NL-19-0107

Edwin I. Hatch Nuclear Plant Units 1 and 2  
License Amendment Request for  
Technical Specifications 3.3.8.1 and 3.8.1 Regarding Unit 1 Degraded Voltage Protection

**Basis for Proposed Changes**

Figure 1 – Current Unit 1 Degraded Voltage Protection Scheme

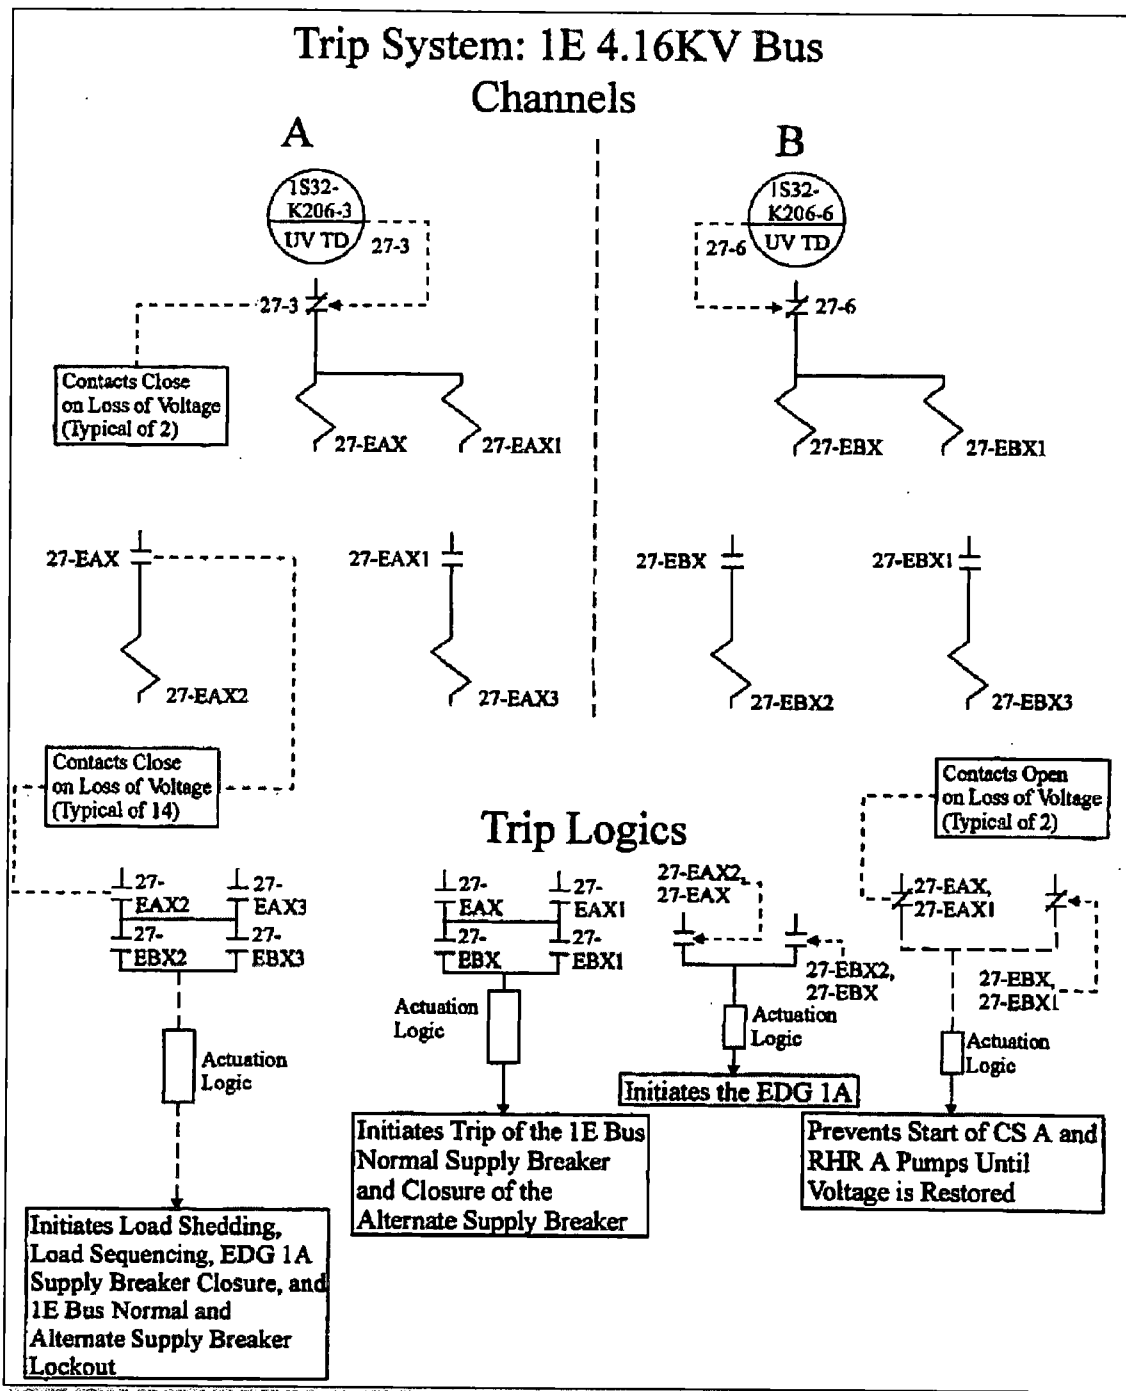
The current degraded voltage instrumentation protection scheme causes an automatic transfer from the primary source to the alternate or emergency source and disconnects certain electrical loads following a time delay. Figure 1, "Current Unit 1 Degraded Voltage Protection Scheme," shows the degraded voltage instrumentation logic for the 1E 4.16 kV emergency bus and associated DG 1A. The current degraded voltage instrumentation logic for each Unit 1 4.16 kV emergency bus is consistent with that shown in Figure 1. As shown in Figure 1, bus degraded voltage for each 4.16 kV emergency bus is monitored by two induction disk type undervoltage relays with inverse time delay and a logic output arranged in a two-out-of-two logic configuration for supported components except the DGs. The DG start logic is arranged in a one-out-of-two configuration.

(Reference 1) through DVR setpoint adjustment alone. Therefore, the existing HNP degraded voltage protection scheme for the Unit 1 emergency buses relies in part on manual actions to assure adequate voltage is supplied to safety-related equipment during design basis events.

In the existing protection scheme, manual action is supported by the low voltage alarm. This alarm alerts plant operators of a degraded grid voltage condition so that they can coordinate with the transmission system operators on actions to restore grid voltage. At present, these manual actions are the means relied on to protect safety-related equipment from inadequate voltages in the range where automatic protection is not provided by the DVRs.

The modified LOP instrumentation design includes two loss of voltage relays per bus (i.e., 6 per Function per unit) and three solid state DVRs per bus (i.e., 9 per Function per unit) with each DVR relay sensing voltage from an electrically independent 4200V/120V potential transformer. Figure 3, "Unit 2 Degraded Voltage Protection Scheme," shows the modified degraded voltage instrumentation logic for the 2E 4.16 kV emergency bus and associated DG 2A. The modified degraded voltage instrumentation logic for each Unit 1 4.16 kV emergency bus will be consistent with the degraded voltage instrumentation logic for Unit 2 as shown in Figure 3 upon completion of the electrical power system modification. As shown in Figure 3, bus degraded voltage is monitored by the three DVRs with fixed time delay for each emergency bus and a logic output arranged in a two-out-of-three configuration for supported components except the DGs. The DG start logic is arranged in a one-out-of-three configuration. A two-out-of-three coincidence logic precludes spurious trips of the offsite power source due to the failure of one instrument channel, while a one-out-of-three DG start logic does not preclude a DG start in the event of a single instrument channel failure.

Figure 2 – Unit 1 4.16 kV Bus Low Voltage Alarm Scheme

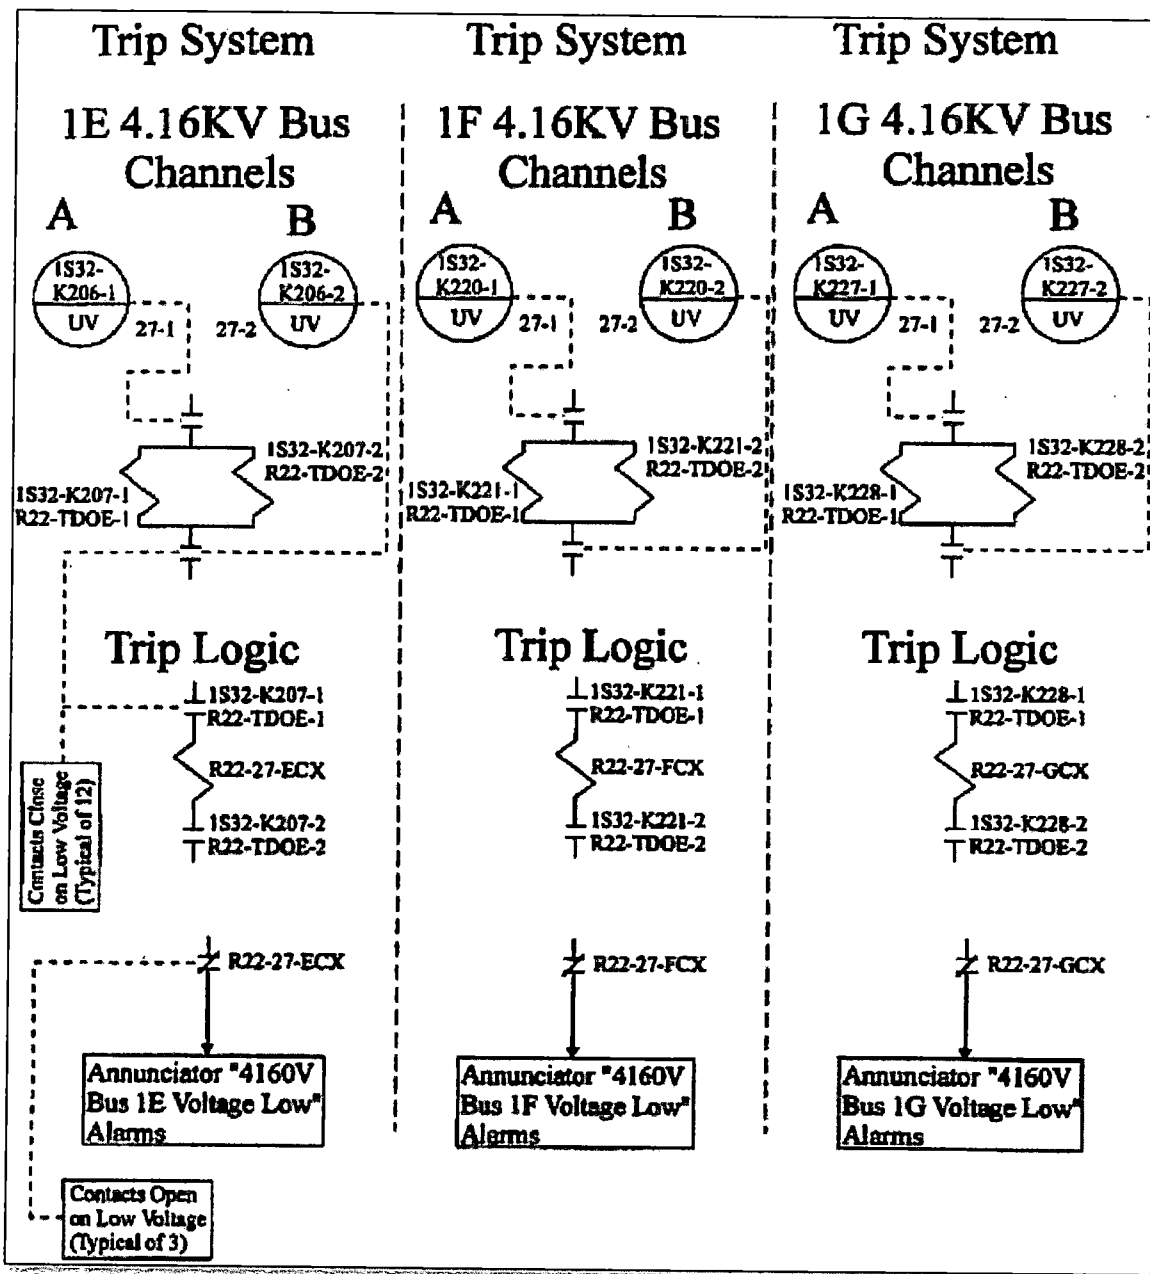
The current low voltage instrumentation protection scheme is similar to the degraded voltage instrumentation scheme with separate loss of voltage relays with different voltage and time delay characteristics. The loss of voltage instrumentation protection scheme and associated setpoints are not altered as a result of the electrical power system modification. Each emergency bus also has a dedicated low voltage annunciator with signal provided from two relays and associated time delays. Figure 2, "Unit 1 4.16 kV Bus Low Voltage Alarm Scheme," shows the annunciation instrumentation logic for the Unit 1 4.16 kV emergency buses. The

logic for the Unit 1 annunciation functions is arranged in a two-out-of-two configuration as shown in Figure 2.
